ADDENDUM NO. 04

PROJECT: BRADFORD CSD - 2023 CAPITAL IMPROVEMENT PROJECT

DATE: 04/04/2025

1
H202.4
1/8" = 1'-0"

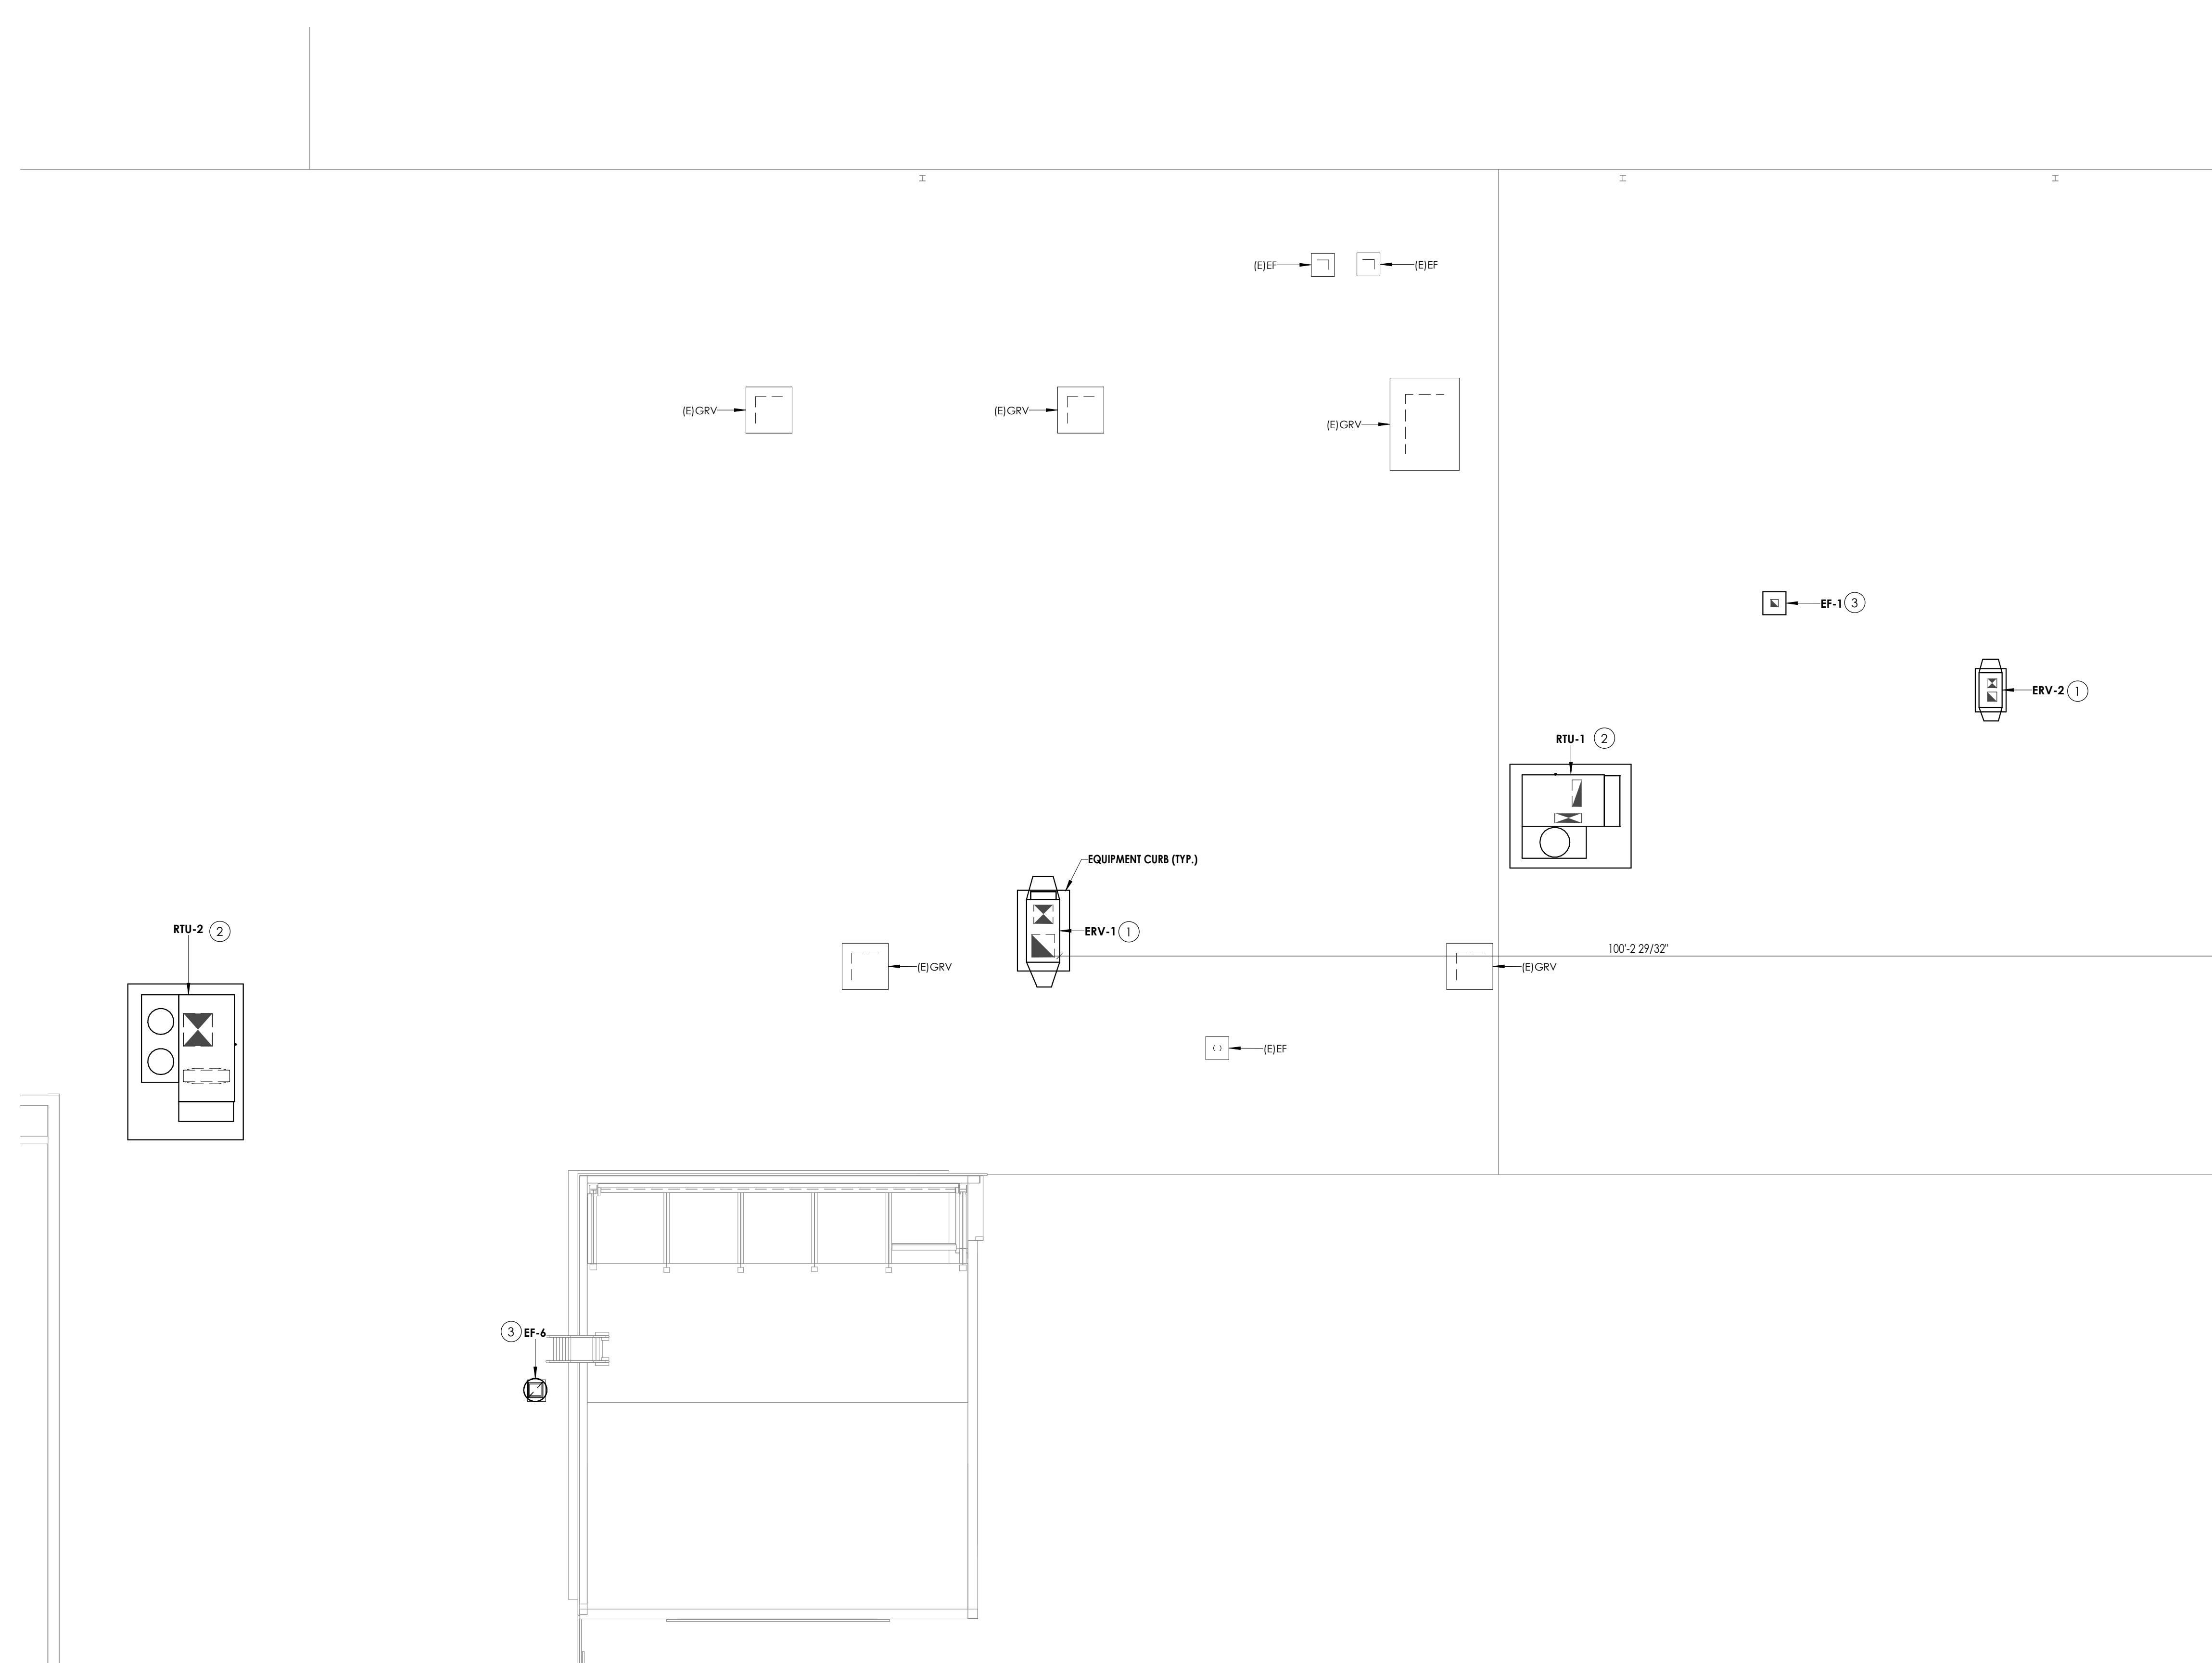
QUESTION: Please clarify the scopes of work for the GC and MC as it pertains to the roof work required for installation of equipment curbs, rails, and pipe portals. Currently shown and noted on MB A-202 & 800 and on MB H-202.1, 202.2, 202.3, 202.4, H302.1, 302.2, 302.3, 302.4

| MB-H202.4 | REMOVED/EDIT COMMENTS TO CLARIFY CONTRACTOR SCOPE OF WORK. |

RESPONSE: All work associated with mechanical work is the responsibility of the mechanical contractor. This includes installation of curbs, rails, and pipe portals. The mechanical contractor is also responsible for cutting, patching, and sealing of roof openings for mechanical equipment. The only work by the general contractor associated with mechanical work will be the structural support steel below the deck as necessary (see RFI FC-05 attached).
